**SCAP REFERRAL – Regulation 23 (2) (b) - COUNCIL COMMENTS
DA 22043097 – 106-108 Unley Road Unley**

Construction of a seven-level mixed-use building comprising residential apartments (floors 1 to 6), shops (ground floor level), car parking, shared amenities and public realm improvements

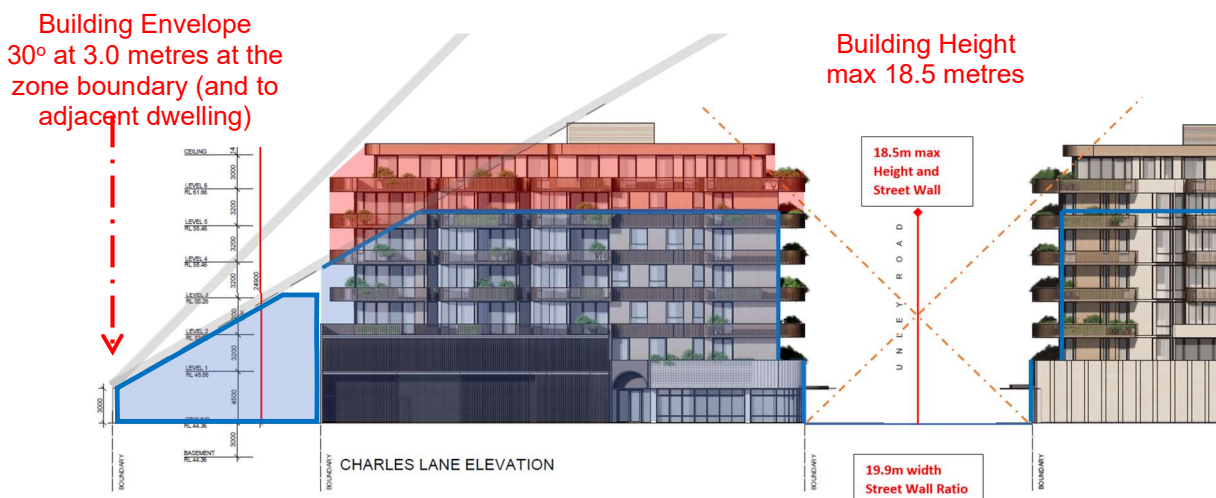
- Existing examples of development on Unley Road are not comparable or relevant, being different locality contexts, nature and scale of site (with site size and depth providing design and functional benefits):
 - 244-246 Unley Road – large site 3,120m² and large depth 74.2 metres;
 - 248-252 Unley Road – large site 2,840m² and large depth 68.3 metres;
 - 166-182 Unley Road – very large site, different Suburban Activity Centre Zone, central heart and core of Unley district, and zone 9 storey height policy limited not being exceeded;
- Building height is also a critical urban design policy that addresses overall visual and building mass, and street wall scale and relationship with the corridor width, important to maintain a human scale, corridor amenity and avoid a canyon of overbearing development;

- There is also a critical intrusion to the Building Interface Envelope (30 degrees at 3m agl) and intent for an appropriate development relationship. The envelope applies from the zone boundary (adjoining residential use in an adjacent low rise Established Neighbourhood Zone) for development of sites within the Corridor Zone, to provide for an appropriate transition between diverse scales of development, limit overbearing building mass and undue overshadowing;
